STAFF REPORT ACTION REQUIRED

2231 Lawrence Ave E – Site Plan Application – Final Report

Date:	June 2, 2009
To:	Scarborough Community Council
From:	Director, Community Planning, Scarborough District
Wards:	Ward 37 – Scarborough Centre
Reference Number:	09 128131 ESC 37 SA

Attachment 1: Site Plan

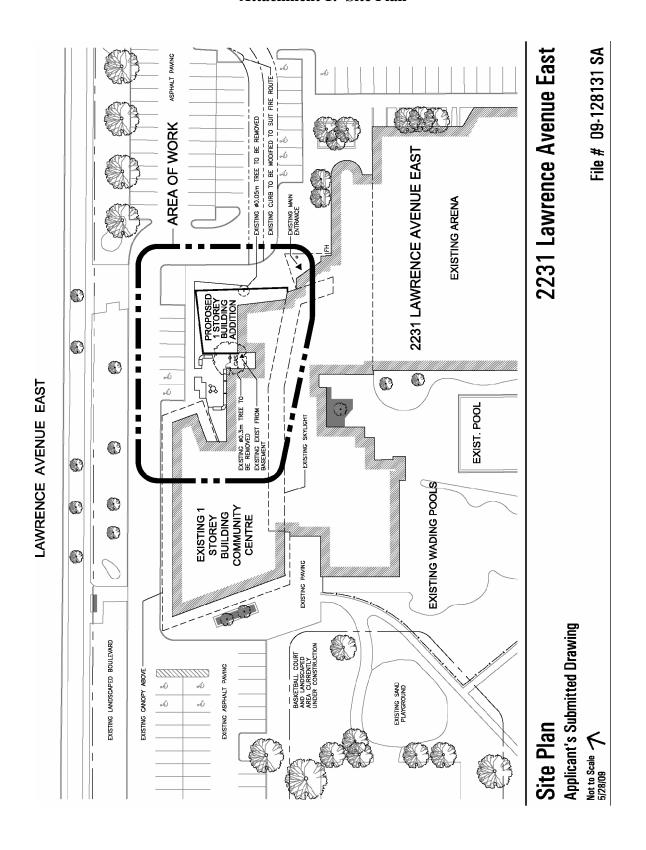
There is an existing divided access driveway from Lawrence Avenue East providing mutual shared ingress over the north-east corner of the subject site, with egress to the street via the adjacent Winston Churchill Collegiate property at 2239 Lawrence Avenue East. Although the former Municipality of Metropolitan Toronto installed a signalized intersection at this location some years ago, Transportation Services staff indicate that acceptable mutual access arrangements (i.e. cross-easements) were apparently never formally created between these two properties. It would therefore be in the best interests for both the City of Toronto and the Toronto District School Board to regularize this currently informal arrangement. The proposed MOU (Attachment 4) therefore includes a provision whereby the Parks, Forestry & Recreation Division will take steps to now secure and formalize the continued shared use of this mutual driveway by both properties.

Secondly, the proposed re-landscaping of the courtyard adjacent to the proposed addition will necessitate removal of two existing trees having a trunk calliper (DBH) of 30 cm and 5 cm. Planning staff have been advised that an acceptable arrangement (as approved by the General Manager, Parks, Forestry & Recreation) has been arrived at internally between Parks Development & Infrastructure Management and Urban Forestry staff. Replacement trees in this regard will be provided in conjunction with the outdoor sports

pad installation project currently underway on the west side of the community centre, as partially indicated on Attachment 1.

As well, it is possible that through further detailed design of the courtyard space sufficient soil volumes might not be achievable to support all three new trees being proposed here. Accordingly, the proposed MOU contains a provision providing for their possible relocation, if necessary, potentially in conjunction with the sports pad project noted above.

Lastly, four 'post and ring' bicycle parking racks currently exist in very close proximity to the east wall of the proposed addition, and may require relocation as part of construction. In accordance with City Council's draft 'Guidelines for the Design and Management of Bicycle Parking Facilities', the proposed MOU contains a provision for the retention of the racks (or their relocation if necessary) and the provision of additional racks in proximity to the main entrance to the community centre.

- 1. The applicant agrees that four existing 'post and ring' bicycle parking racks adjacent to the proposed addition will be maintained during construction or, if that is not possible, permanently relocated near the main building entrance as necessary, together with the provision of 6 additional bicycle racks, to the satisfaction of the Director, Community Planning, Scarborough District.

- D) The applicant further undertakes to initiate the creation and formalization of a mutual right-of-way with the Toronto District School Board for the existing shared driveway access from Lawrence Avenue East currently serving the subject property and Winston Churchill Collegiate at 2239 Lawrence Avenue East. to the satisfaction of the Executive Director of Technical Services.
